TO: **COUNCIL ASSESSMENT PANEL**
 DATE: **28 OCTOBER 2020**
 SUBJECT: **COUNCIL ASSESSMENT REPORT**
 AUTHOR: **DEAN SPASIC**
DEVELOPMENT OFFICER - PLANNING

DA NO.	:	<u>110/00418/20</u>
APPLICANT	:	<u>WILCOT DRAFTING</u>
LOCATION	:	<u>282 SEACOMBE ROAD, SEACLIFF PARK</u>
DEVELOPMENT PLAN	:	<u>CONSOLIDATED 2 JUNE 2016</u>
ZONE AND POLICY AREA	:	<u>RESIDENTIAL ZONE</u>
NATURE OF DEVELOPMENT:		<u>MERIT</u>
PROPOSAL	:	<u>CONSTRUCTION OF A TWO STOREY DETACHED DWELLING WITH GARAGE WALL ON EASTERN SIDE BOUNDARY AND SINGLE STOREY DETACHED DWELLING</u>
EXISTING USE	:	<u>RESIDENTIAL</u>
CATEGORY	:	<u>TWO</u>
REPRESENTATIONS	:	<u>TWO</u>
RECOMMENDATION	:	<u>DEVELOPMENT PLAN CONSENT SUBJECT TO CONDITIONS</u>

1 Site Plan 1:200

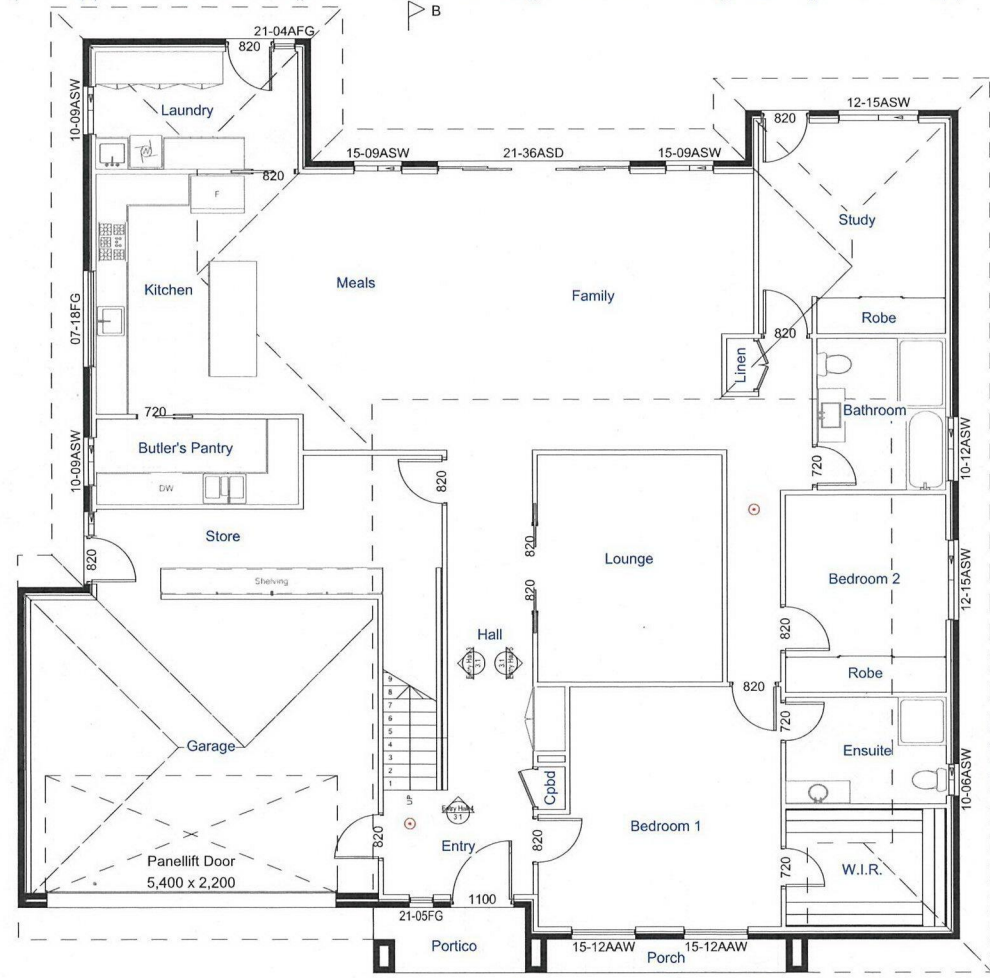
Two storey dwelling	Development Plan	Proposed	Complies
Site coverage	50%	47%	Yes
Private open space	20%	26%	Yes
Primary street setback	Average of adjacent buildings (average 6m)	6.4m	Yes
Ground level side setback	Wall on boundary 3m high x 8m long 900mm	Wall on boundary not more than 3m high and 8m long 1.2m+	Yes
Upper level side setback	2.5m	3.4m+	Yes
Ground level rear setback	4m	5m	Yes
Upper level rear setback	6m	10.4m	Yes
Single storey dwelling	Development Plan	Proposed	Complies
Site coverage	50%	46%	Yes
Private open space	20%	28%	Yes
Primary street setback	Average of adjacent buildings (average 1m)	4m	Yes
Ground level side setback	Wall on boundary 3m high x 8m long 900mm	Carport on boundary 1m	Yes
Ground level rear setback	4m	4m	Yes

1 Northern Elevation
1:100

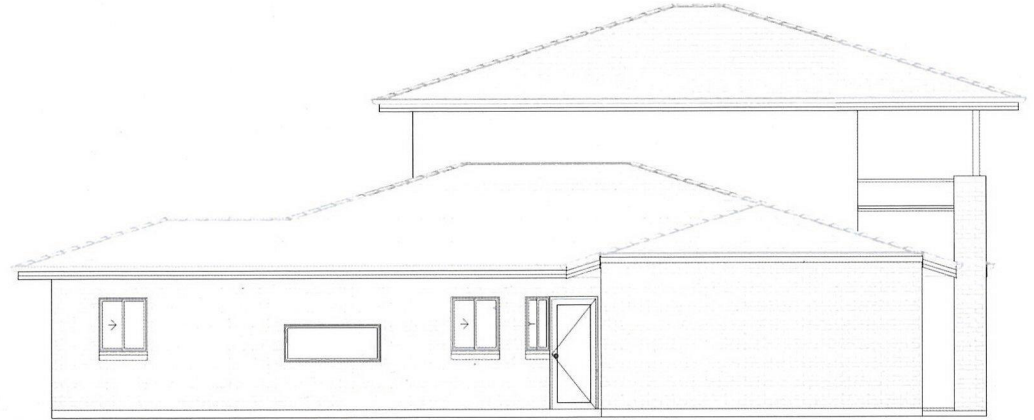
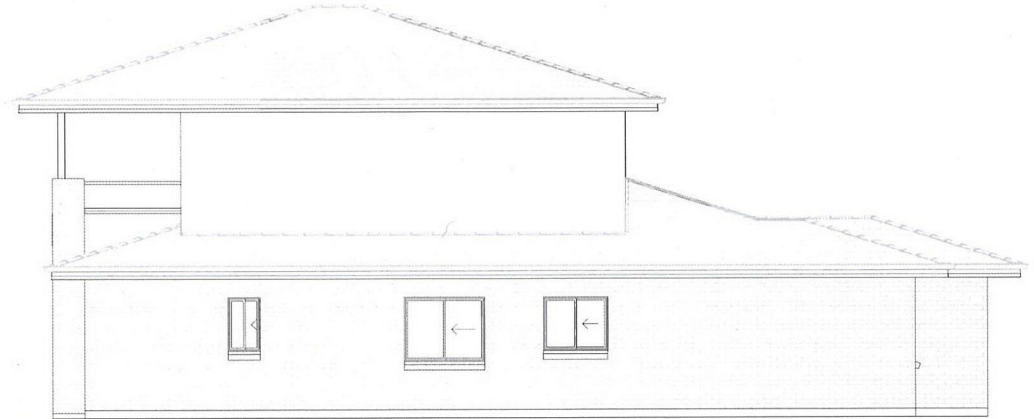
The upper level windows of the two storey building on the side and rear elevations will be obscured up to 1.7 metres above the floor level so as to ensure the visual privacy of adjacent properties is not compromised.

DEVELOPMENT # 110/00418/20: I am the owner of Unit 2, 280 Seacombe Rd Seacliff Park, which adjoins the proposed development. Having examined the application and visited the proposed site on July 17, it is apparent that the privacy of residents of the adjoining units would be compromised by the inclusion of an upper level balcony on the development. I believe the Council Assessment Panel should give due consideration to the impact the development will have on the privacy of the residents of the adjoining units, and take whatever steps are necessary to rectify this issue. In this instance, the removal/re-design of the proposed balcony may suffice. I am willing to appear personally in support of this submission. Fiona Bolton

3. That all upstairs windows on the side and rear elevations shall have minimum window sill heights of 1.7 metres above finished floor level, or any glass below 1.7 metres shall be manufactured obscure glass and fixed shut or as otherwise approved by Council. Further details of this requirement shall be provided at Building Rules Assessment stage.

4. Balconies shall comprise fixed screens up to 1.7 metres in height, measured above the balcony floor level so as to ensure the visual privacy of adjacent residences is not compromised. Further details of this requirement shall be provided at Building Rules Assessment stage.
